## TECHNICAL BULLETIN

# CONNECTING TRUNK PRESSURE CONTROL

TO ENABLE CHAMBER CONNECTING TRUNK (SPOOL) PRESSURIZATION / DEPRESSURIZATION TO BE PERFORMED BY EXTERNAL COMMAND.

FIGURE 2. NEW CONFIGURATION PROPOSED

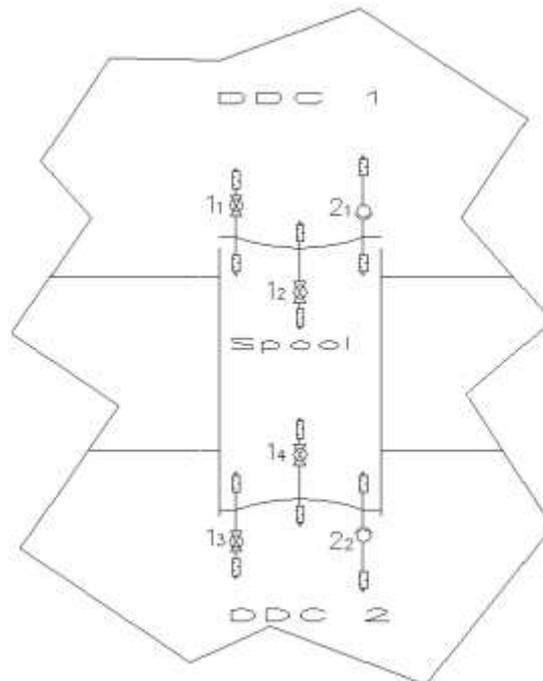
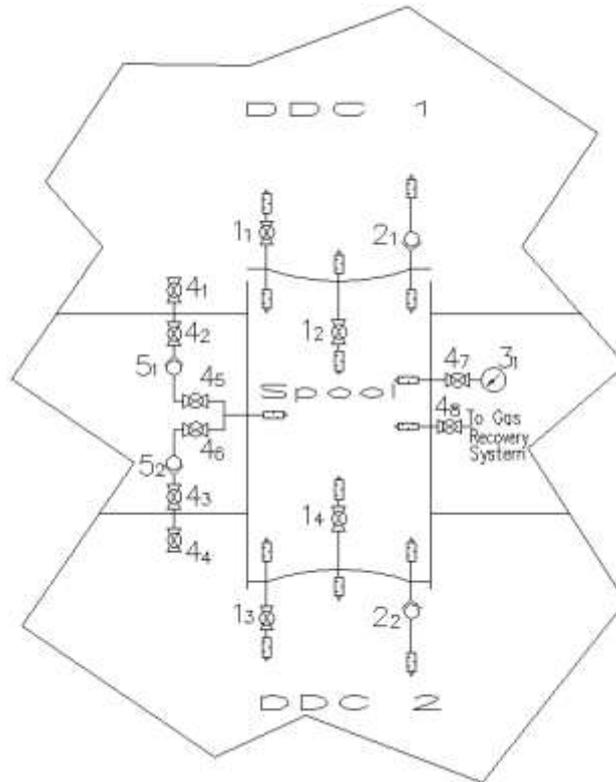
THE NEW CONFIGURATION PROPOSED ALLOWS THE PRESSURIZATION AND DEPRESSURIZATION OF THE SPOOL BY AN EXTERNAL VALVE SYSTEM.

TO PRESSURIZE THE SPOOL, THE EXTERNAL OPERATOR CAN OPEN THE PRESSURIZATION VALVE OF THE CHAMBER PRESSURIZED AT THE LOWER PRESSURE (FOR EXAMPLE V4-5 ON FIGURE 2) AND WILL BE ABLE TO CHECK THE ACTUAL PRESSURE INSIDE THE SPOOL ON PRESSURE GAUGE M3-1.

WITH THE NEW CONFIGURATION IT WILL BE POSSIBLE TO COMPLETELY DEPRESSURIZE THE SPOOL TO OBTAIN A BETTER INSULATION BETWEEN THE CONNECTED CHAMBERS. TO DEPRESSURIZE THE SPOOL, THE EXTERNAL OPERATOR OPENS VALVE V4-8 AND CAN CHECK THE PRESSURE INSIDE THE SPOOL ON PRESSURE GAUGE M3-1.

THE ORIGINAL CONFIGURATION WILL BE MAINTAINED IN ORDER TO ALLOW THE INTERNAL DIVERS TO BE ABLE TO PERFORM THE EQUILIBRIUM OPERATION.

- REMOVE THE INSULATION FROM THE SPOOL
- CREATE 3 THREADED HOLES (1/4" NPT) ON THE SPOOL
- PERFORM A HYDRAULIC TEST ON THE MODIFIED SPOOL AT 47.1 BAR
- REINSTALL THE INSULATION AROUND THE SPOOL
- INSTALL 2 VALVES (ONE ON THE INTERNAL AND ONE ON THE EXTERNAL SIDE OF EACH HYPERBARIC CHAMBER) ON A SPARE COUPLING ON EACH HYPERBARIC CHAMBER
- INSTALL THE NEW COMPONENTS ON THE SPOOL
- CONNECT THE NEW COMPONENTS WITH THE HYPERBARIC CHAMBERS (PIPING ACTIVITY)
- PERFORM A LEAKAGE TEST OF THE NEW SYSTEM (CHAMBERS AND SPOOL TOGETHER) AT 31.4 BAR

IT MUST BE NOTED THAT IN ORDER TO PERFORM THE MODIFICATION ON THE SPOOL BODY IT IS NECESSARY TO DISCONNECT THE SPOOL.
